# GWH Response to UDCG Meeting 21st March 2018

# **URBAN DESIGN CONSULTATIVE GROUP MEETING**

386 King Street

Sky Apartments

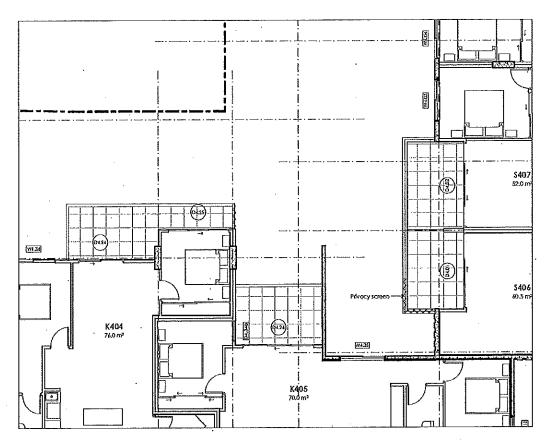
The very small separation distances between balconies at the internal corner
interface with balconies in the tower block result in unacceptable privacy impacts.
Note that in the approved scheme there was significantly greater separation between
apartment balconies, and the balcony to the communal spaces had projecting blade
walls, - although these too were barely adequate to deal with privacy.

Response: The separation distances between the balconies of the Hunter and King Street towers have been adjusted to reflect to the approved scheme and privacy screens have also been provided, as indicated below and on amended plans as attached.

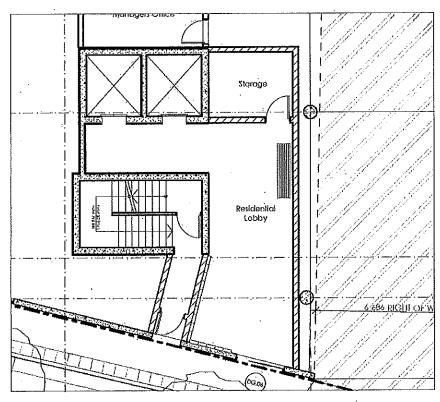
The main entrance at ground floor appears to have no lobby or enclosure. Given the southern orientation and the adjacent vehicle entrance this would be somewhat bleak for the many residents and visitors who would not arrive by vehicles. An attractive enclosed lobby with at least a small seating area should be provided.

Response: An attractive enclosed lobby, large enough to provide a small seating area has now been provided, with access directly from King Street, as indicated below.
